SP 3-820-001
SERVICE PROGRAM

Xpeditor Starter Spacer Installation.

This Service Program provides information regarding the installation of a starter spacer.

Figure 1

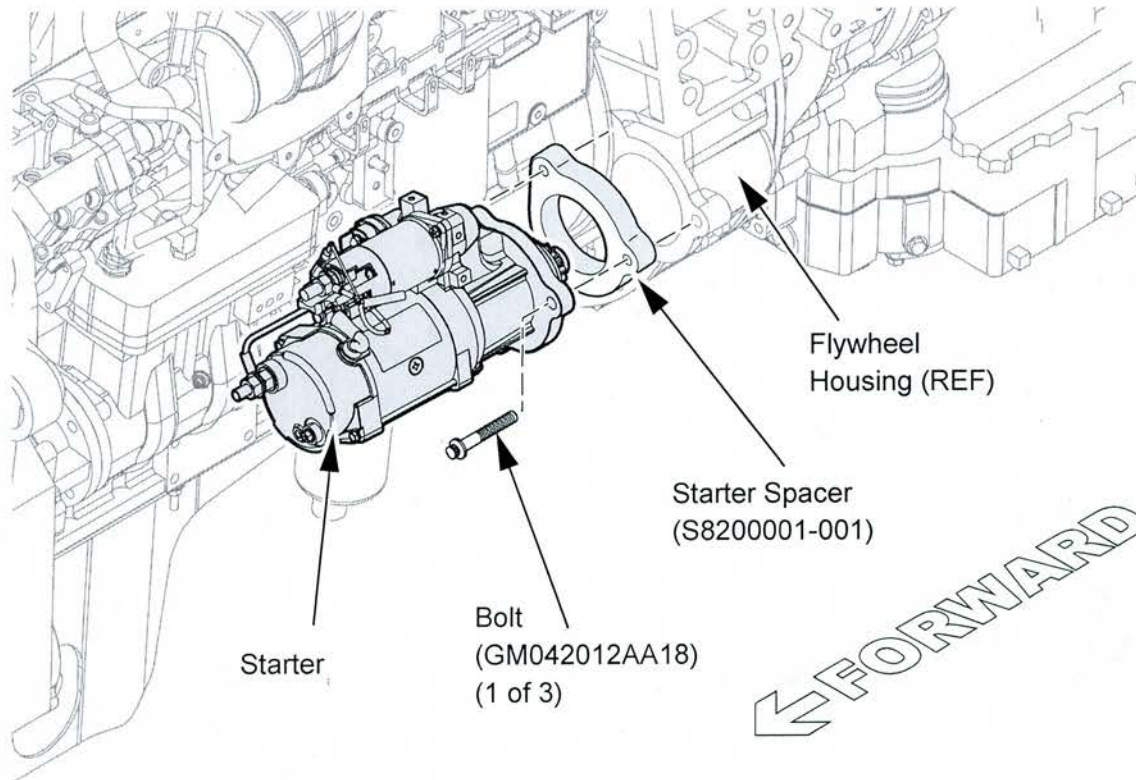
1. Locate the starter (see Figure 1).
2. Remove the three bolts and discard.
3. Remove the starter (see Figure 1).
4. From the service kit (S8200002K001), install the starter spacer (S820001-001) (see Figure 1).
5. From the service kit (S8200002K001), install the three bolts (GM042012AA18) and tighten to 55 ft-lbs (74 N·m) of torque (see Figure 1).
6. Check starter operation by starting the engine.
7. Installation of starter spacer is complete.
